APPLICATION NO.	FILING DATE	FIRST NAMED INVENTOR	ATTORNEY DOCKET NO.	CONFIRMATION NO.
10/849,697	05/20/2004	Lucretia Sessano	SESSANO ET AL 1	7641
25889	7590	04/06/2007	EXAMINER	
WILLIAM COLLARD COLLARD & ROE, P.C. 1077 NORTHERN BOULEVARD ROSLYN, NY 11576			HANSEN, JAMES ORVILLE	
			ART UNIT	PAPER NUMBER
			3637

Office Action Summary

DETAILED ACTION

FIG. 2

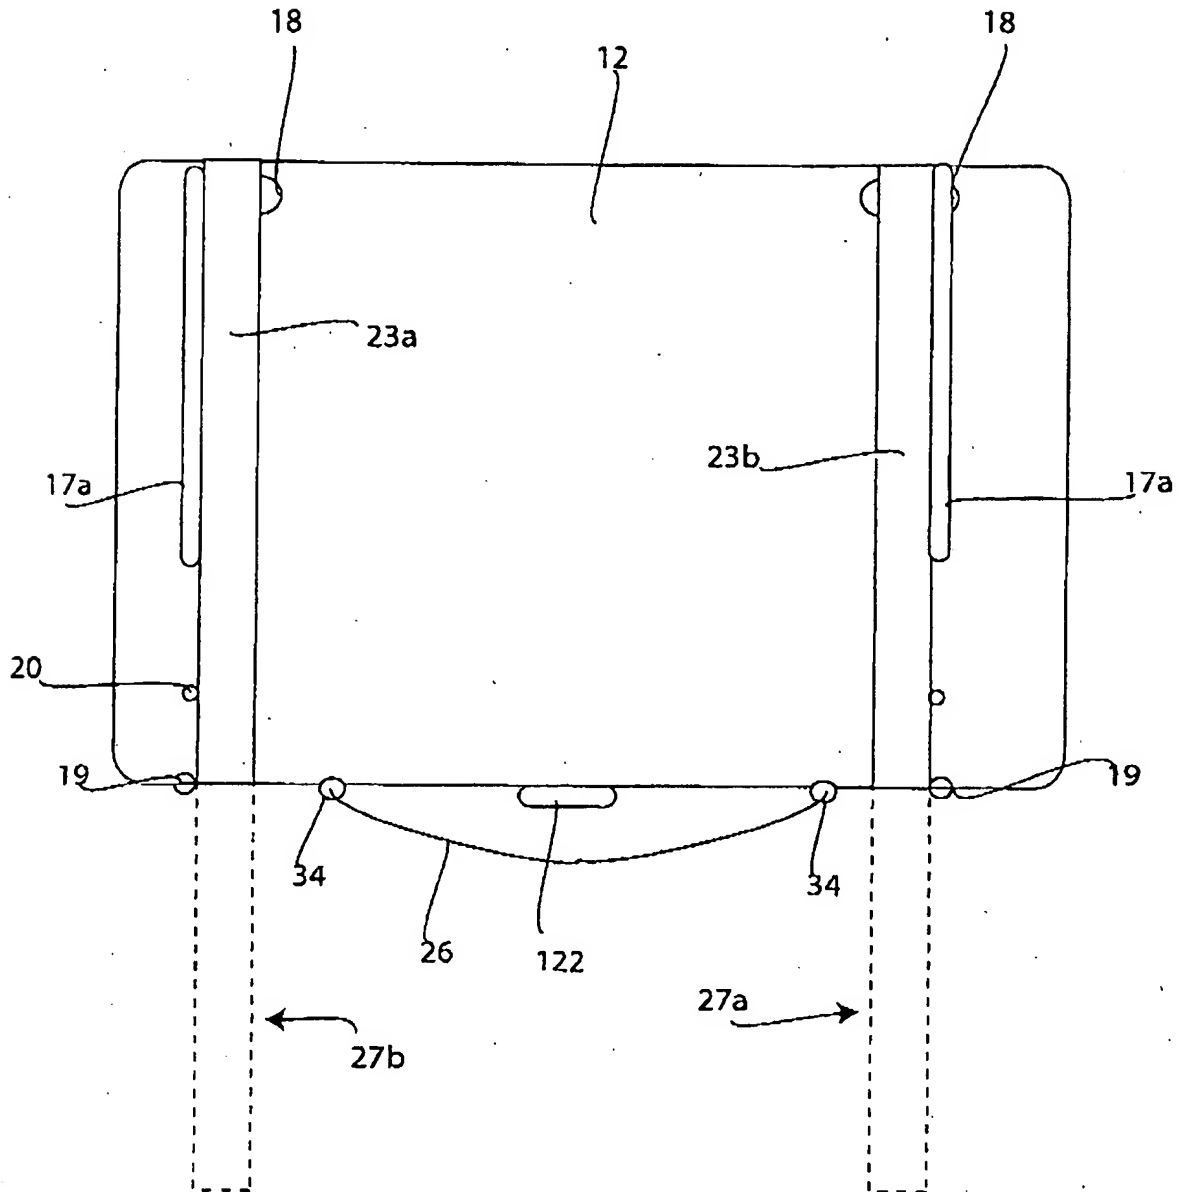
Approved for examination purpose
for 3/30/07

FIG. 3

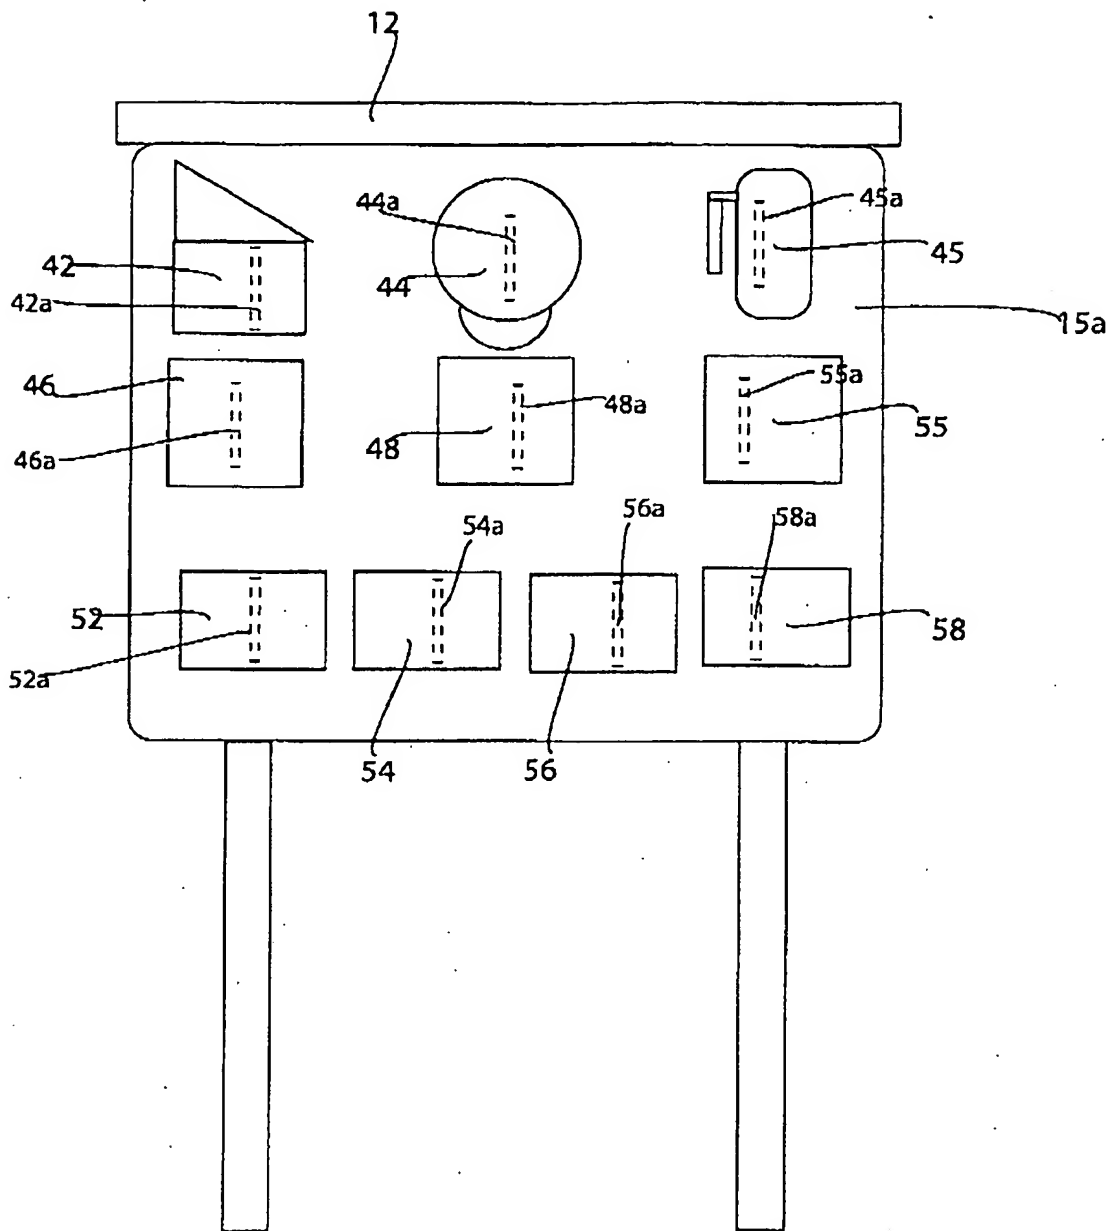
Approved for Examination purposes
Apr 3/30/07
